National Fire Protection Association

MEMORANDUM

SUBJECT: NFPA 13D ROP TC Letter Ballot (A2012)

13D-1 Log #CP2 AUT-RSS
(Entire Document)

Figure 8.3.3.2.1(1)

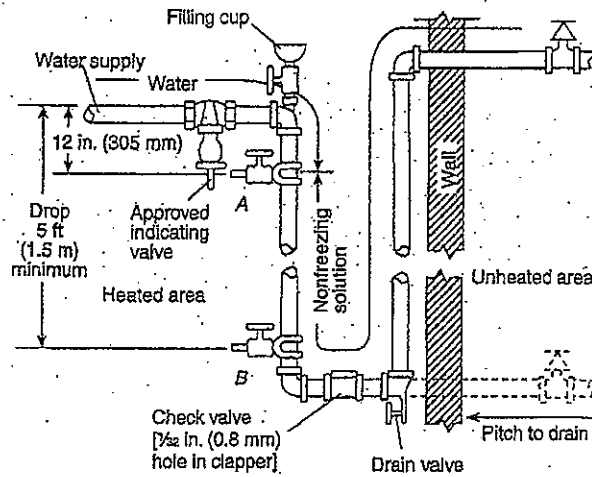
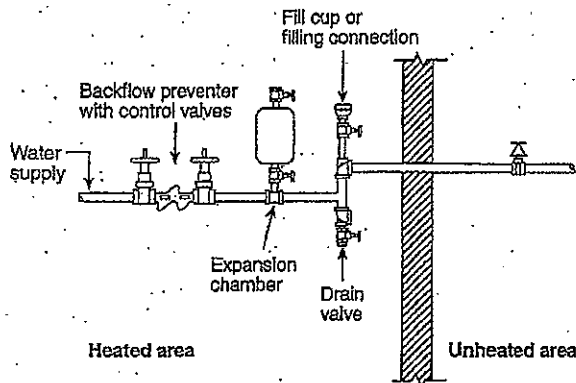
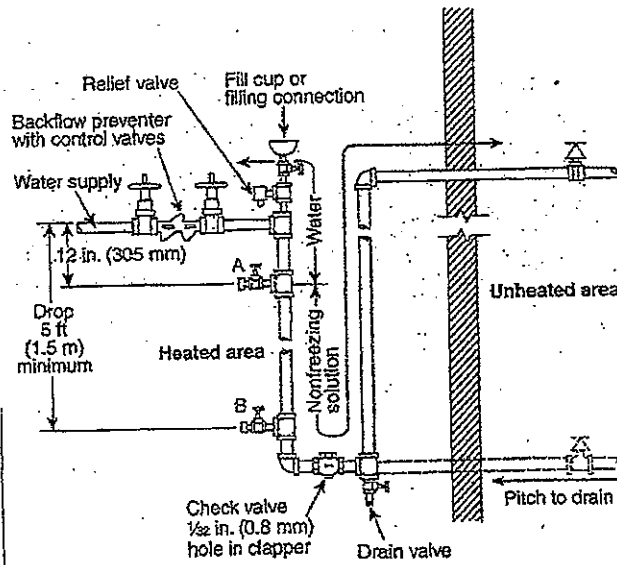
(1)* An antifreeze loop and a check valve with a 1/32 inch hole drilled in the clapper as shown in Figure 8.3.3.2.1(1).

(2)* A backflow preventer and a listed expansion chamber as shown in Figure 8.3.3.2.1(2). The expansion chamber shall be properly sized taking into account the precharge air pressure and precharge air temperature. The size of the expansion chamber shall be such that the maximum system pressure does not exceed the rated pressure for any components of the antifreeze system.

(3) Where the antifreeze system volume does not exceed 40 gallons, a backflow preventer and a listed pressure relief valve as shown in Figure 8.3.3.2.1(3).

Figure A.8.2.6(1) Dry Sidewall Sprinkler Through Wall

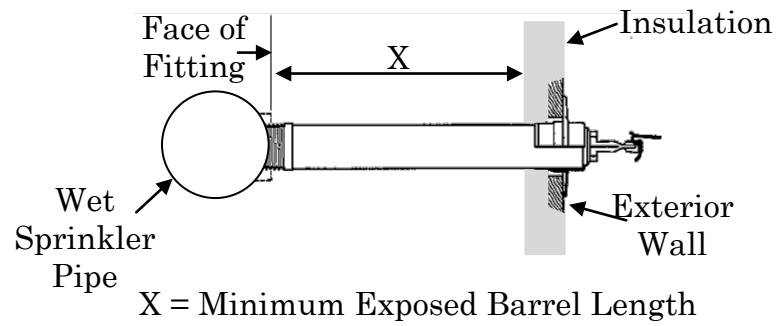
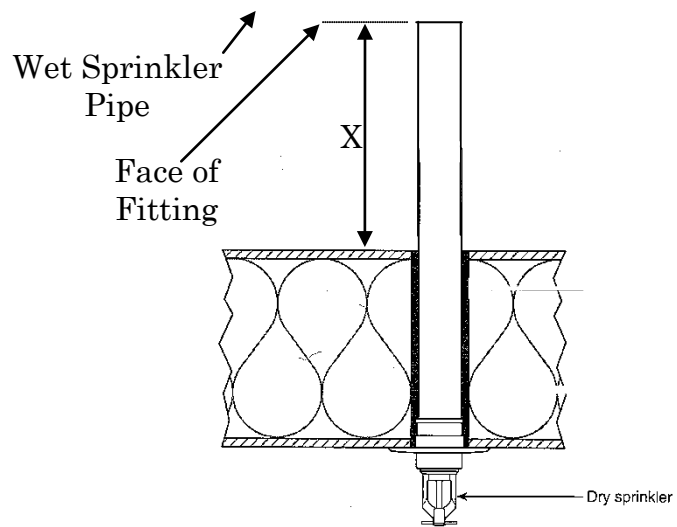
Recommendation: Add a new 8.2.6 and an annex note as follows:

13D_Log_CP17_Figure_A.6.2.(a)

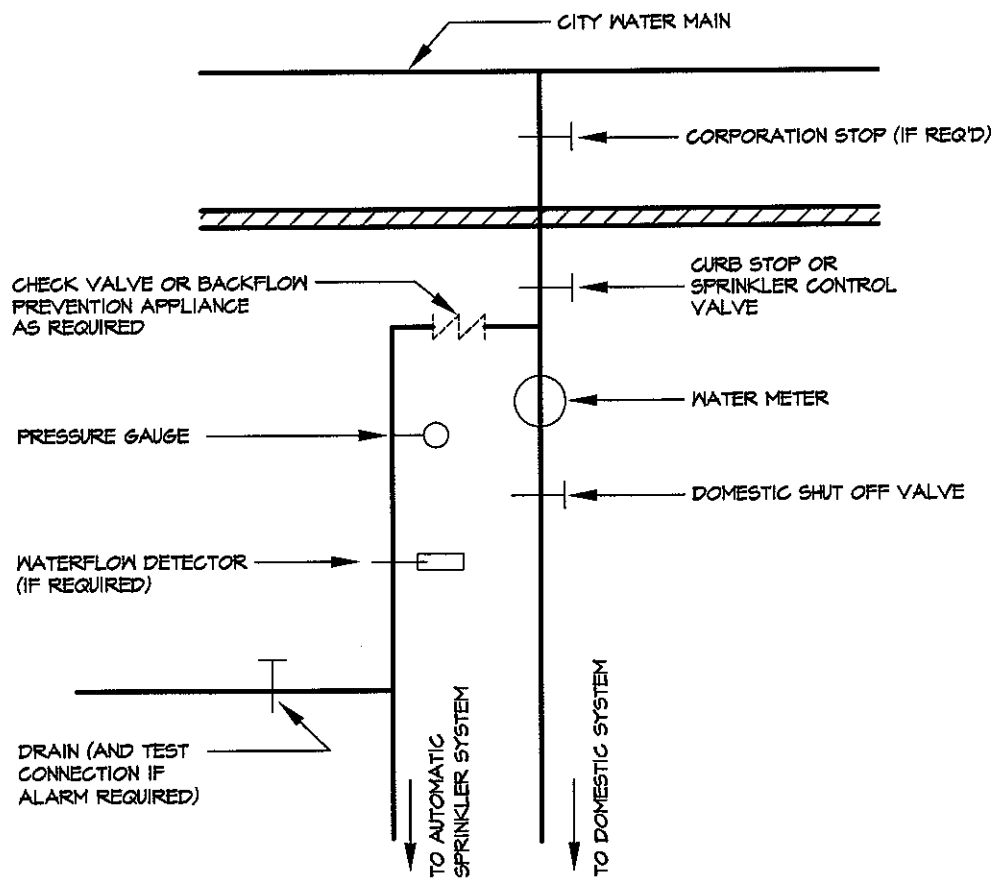
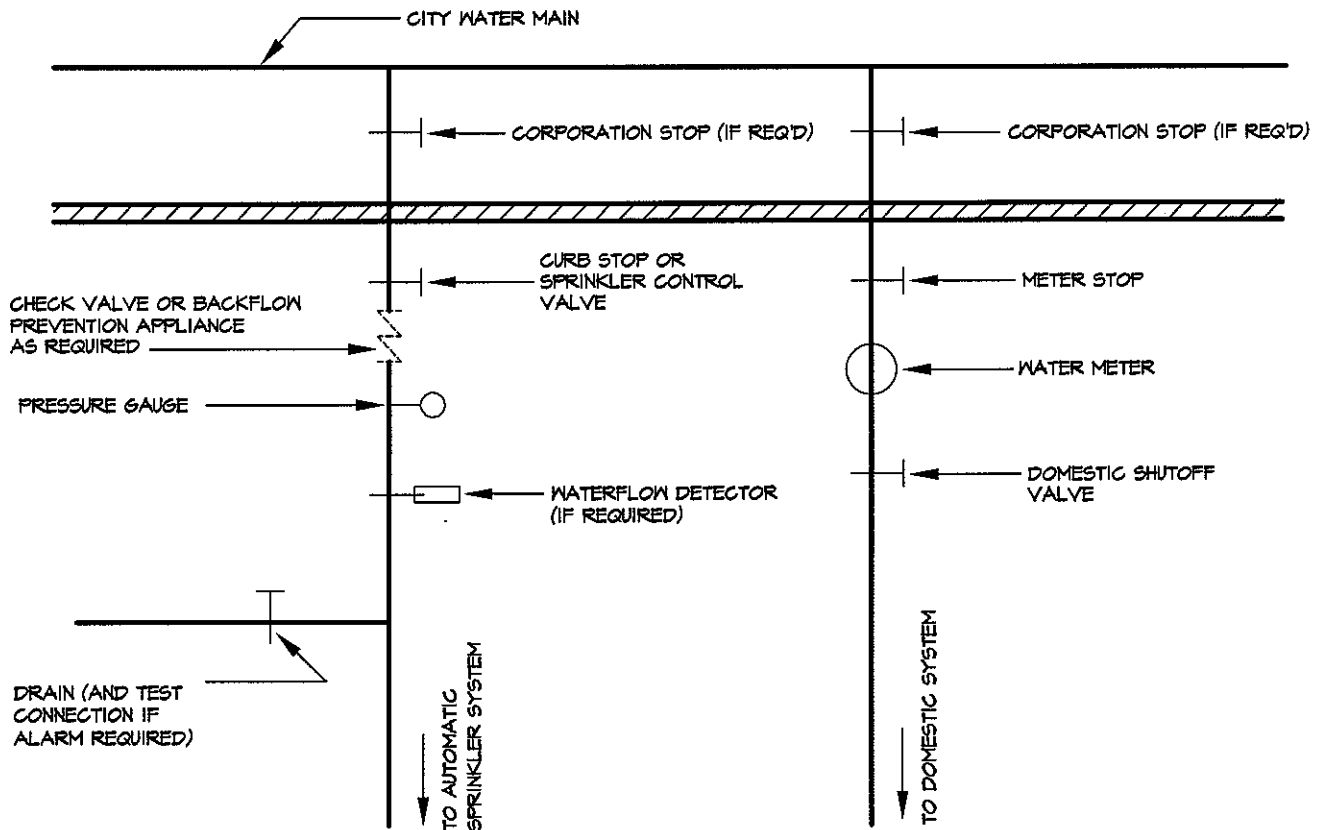
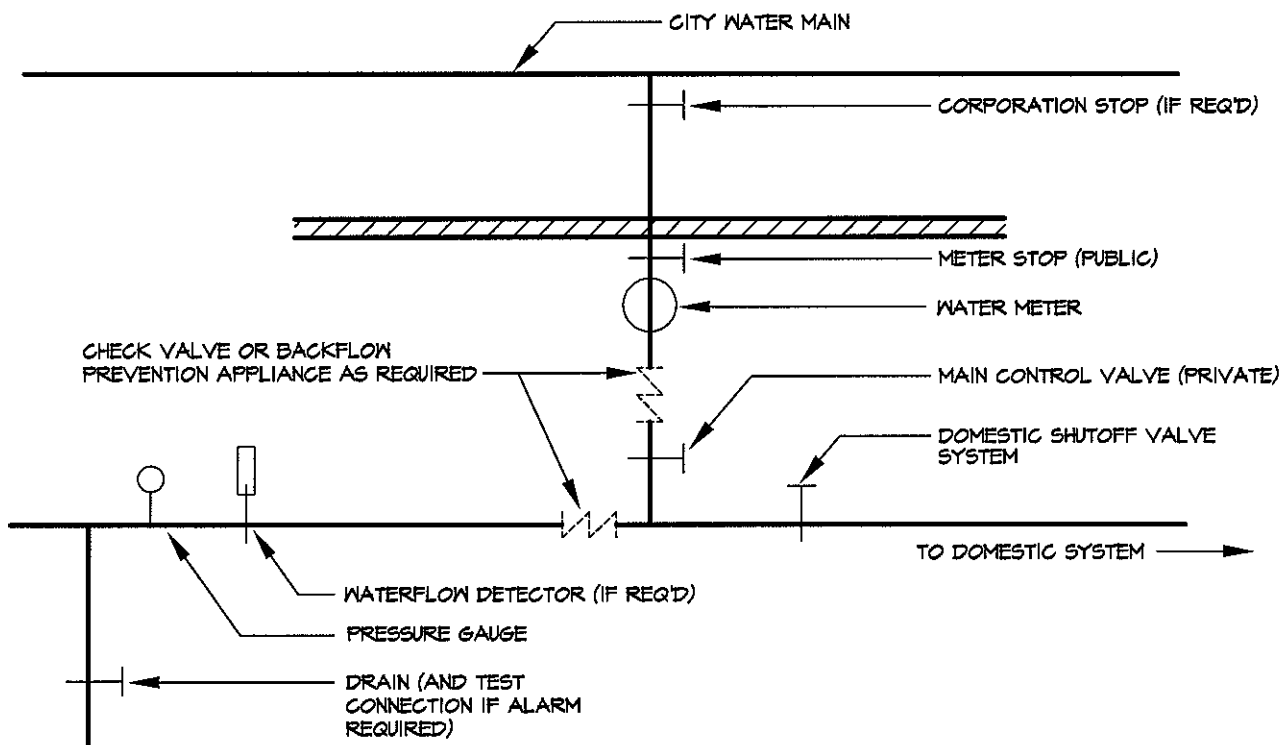
Recommendation: Revise Figures A.6.2(a)(b)(c) as follows:

Substantiation: Figures need to be updated.
